Subject: Crystal River Unit 3  
Docket No. 50-302  
Operating License No. DPR-72  
Additional Response to Bulletin 88-11

Subject: Babcock & Wilcox Owners Group Response to NRC Bulletin  
88-11, "Pressurizer Surge Line Thermal Stratification"

B&W Owners Group Responses to  
NRC Questions on BAW-2085

B&W OWNERS GROUP RESPONSE TO NRC QUESTION 5.9  
ON BAW-2085

Figure 1

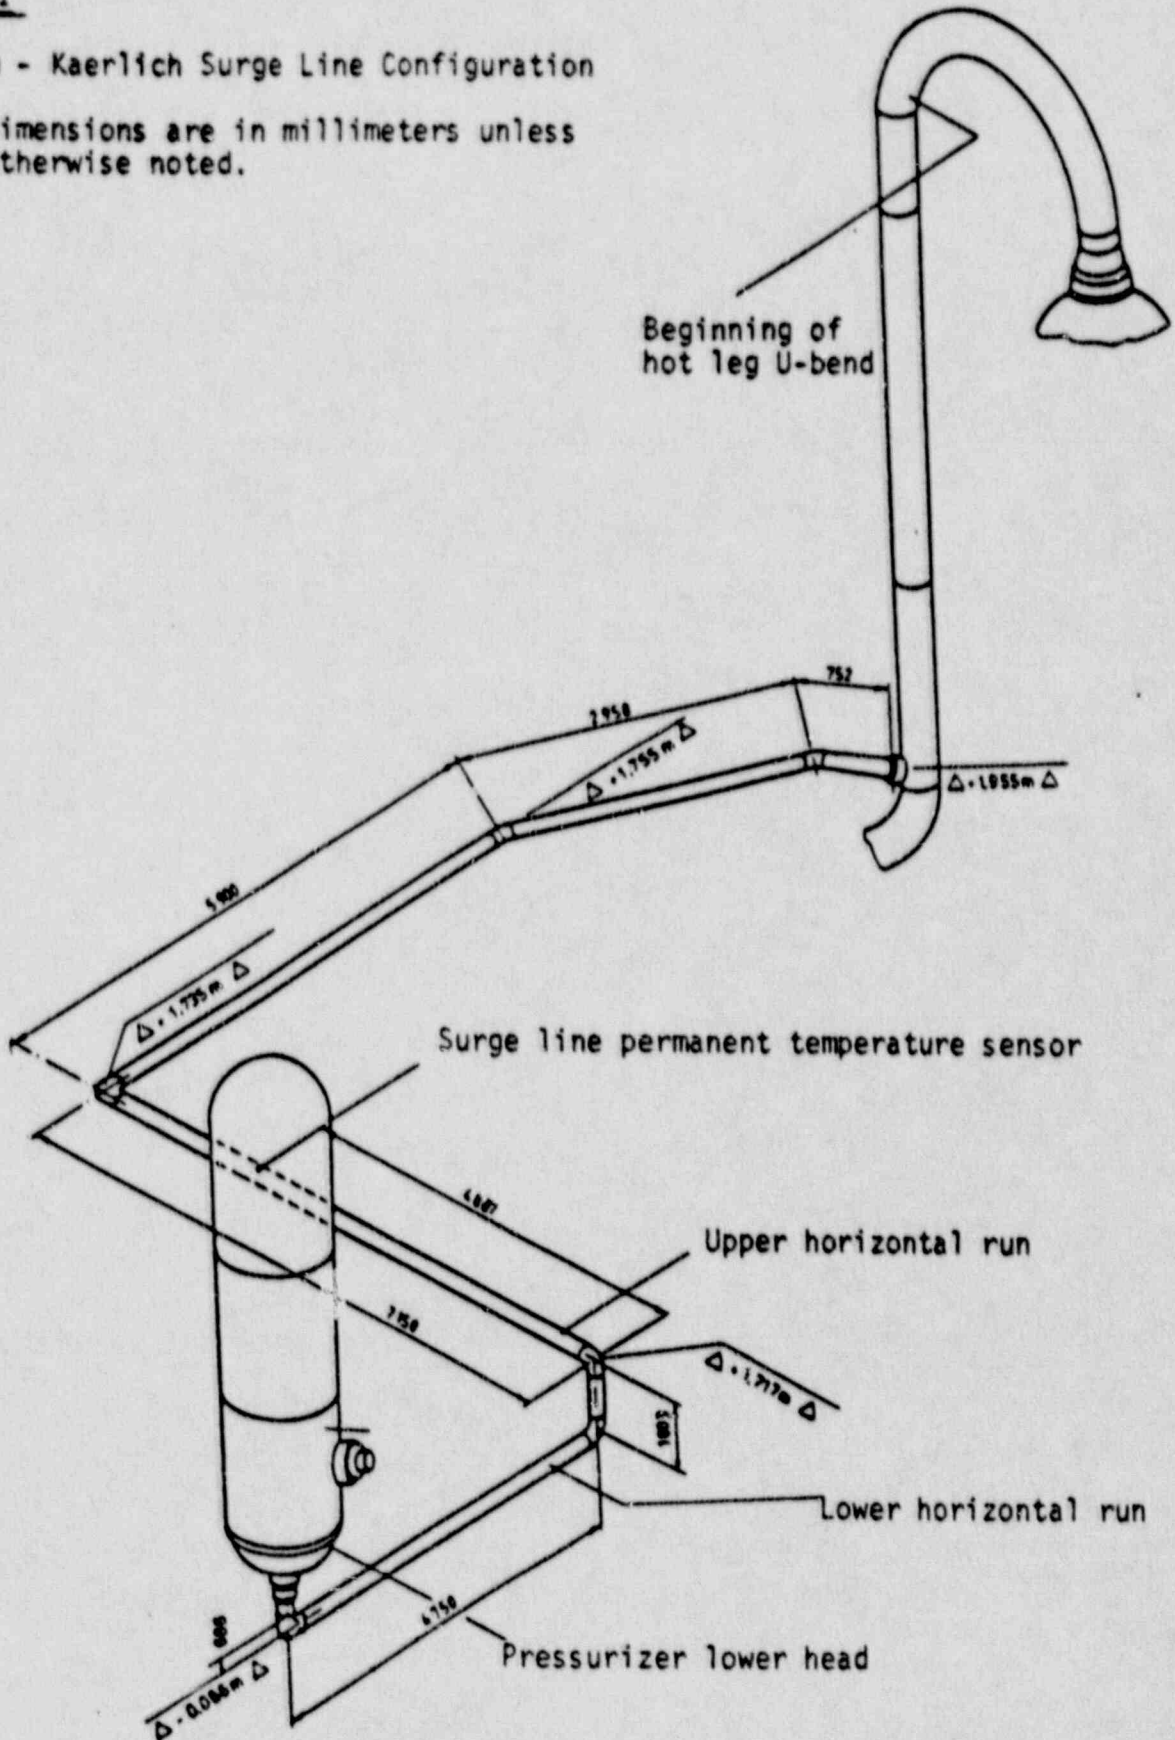
What are the specific differences between the Muelheim-Kaerlich (M-K) plant and the domestic plants?

The M-K plant is a two-loop pressurized water reactor (PWR) with two cold legs in each loop, each with its own reactor coolant pump. The plant employs a pressurizer and associated spray line and surge line functionally similar to typical U.S. PWRs.

The M-K plant's surge line dimensions and configuration are somewhat different from the domestic 177 fuel assembly plants' surge lines. BAW-2085 includes the specific information for the dimensions and configuration of the domestic plant surge lines. Figure 1 shows the M-K surge line configuration. The total line length at M-K is approximately 78 feet compared to about 50 feet for the domestic plants. The M-K configuration also contains a vertical rise in the line about 16 feet away from the pressuri-

zer, somewhat similar to the configuration at the Davis-Besse plant. However, the upper horizontal run at M-K is significantly longer than its counterpart at Davis-Besse.

The surge line inside diameter at M-K is approximately 15.7 inches versus 8.75 inches on the domestic plants. The straight pipe wall thickness at M-K is 1.8 inches versus the domestic plant value of 1 inch. M-K has removable stainless steel insulation on the surge line similar to that manufactured by B&W and used on most of the domestic surge lines.
